SIB 61 02 08 Wiring Harness Chafing

****Technical Campaign****

Subject: F 650 GS (R13) Wiring Harness Repair

Model: F 650 GS and F 650 GS Dakar (R13)

Figure 1: weld spatter

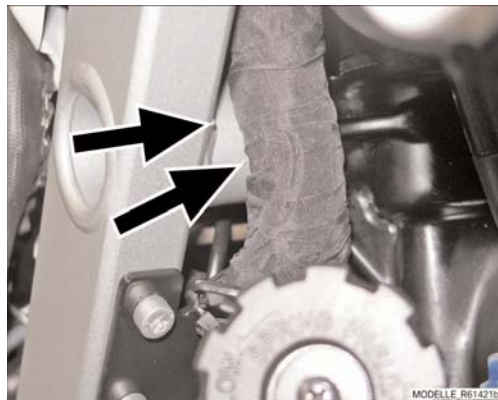
Details: The wiring harness of the F 650 GS and F 650 GS Dakar (R13) models is routed along the right-hand top rail of the frame. Weld spatter on the frame and/or adverse routing in the vicinity of the banjo bolt of the hydraulic spring base adjuster can result in chafing of the wiring harness. If this goes unnoticed, in extreme cases it can result in a broken wire or shorting and lead to malfunctions. See figures 1-3.

- 3) Examine the frame for weld spatter. Weld spatter on the welded-in round tube is critical, and the same applies to weld spatter on the inboard side of the rectangular section frame tube (see Figure 1). Remove weld spatter, if present, with a scraper or chisel. Usually only a small amount of force is necessary to chip off weld spatter. Touch up damage to the paintwork with a touch-up pencil, for example BMW part number 51 91 0 302 241 (concealed areas).

Figure 4: second cable tie

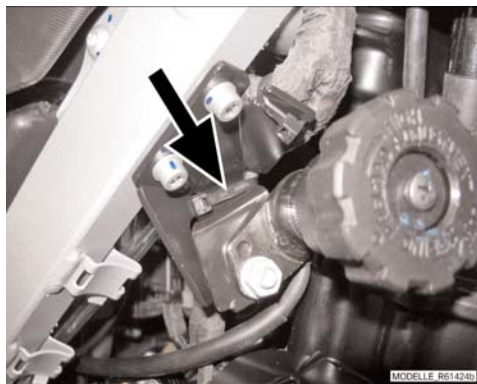
- 4) Use two cable ties (as shown in Figures 4 & 5) to secure the wiring harness to the bracket of the adjuster knob, making sure that the wiring harness is routed clear of the banjo bolt by a sufficient margin.
